GPT-40K CAPACITOR
DISCHARGE CIRCUIT MOD. (KIT- 116)

TMC SPECIFICATION NO. S-610

I. Equipment Affected:

A. GPT-40K

GPT-40K CAPACITOR
DISCHARGE CIRCUIT MOD. (KIT-116)

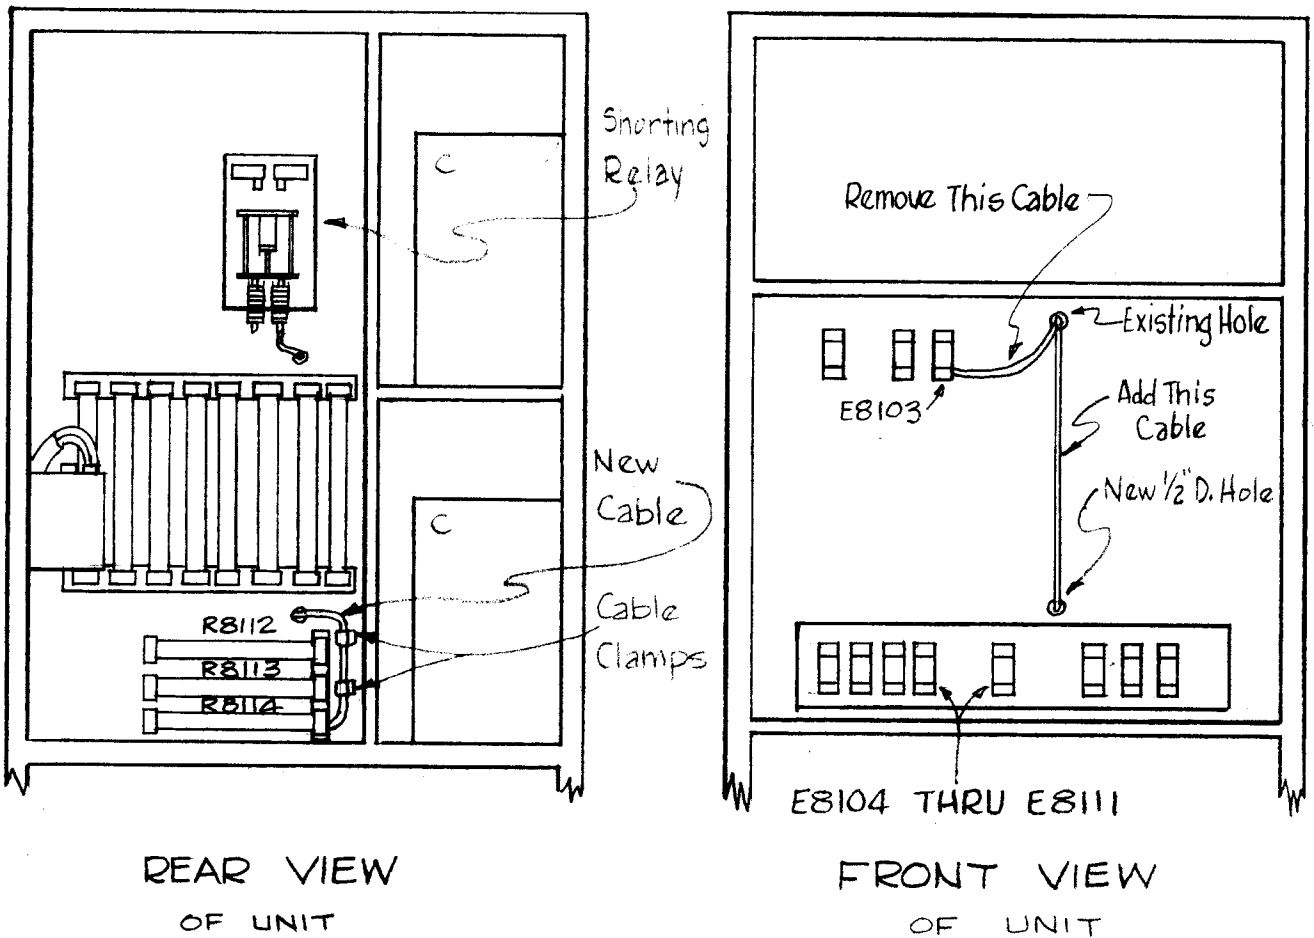
A. Modification to permit discharging of capacitors C8108, C8107 in the event resistors R8112, or R8113, or R8114 breaks down and causes an open circuit preventing the capacitors from discharging.

1. Remove AC Power from unit.
2. Remove crowbar drawer and high voltage rectifier drawer.
3. Short all capacitors to ground with shoring bar.
4. Remove cable from terminal E8103 up to shorting relay.
5. From the front of the unit drill $\frac{1}{2}$ inch hole in bakelite board directly under hole from which the old cable was removed and $\frac{1}{2}$ inch above the board on which the terminals E8104 thru E8111 are mounted
6. Add cable supplied CA-412-4-29.00 from the shorting relay through the original hole down to the new drilled hole through the hole and down past the right side of resistors R8112, R8113, and R8114 and connected to the right side of resistor R8114.
7. Use the two existing nuts to the right side of resistors R8112, R8113, and R8114 and the two cable clamps supplied, CU-102-2. to attach the cable to the board.
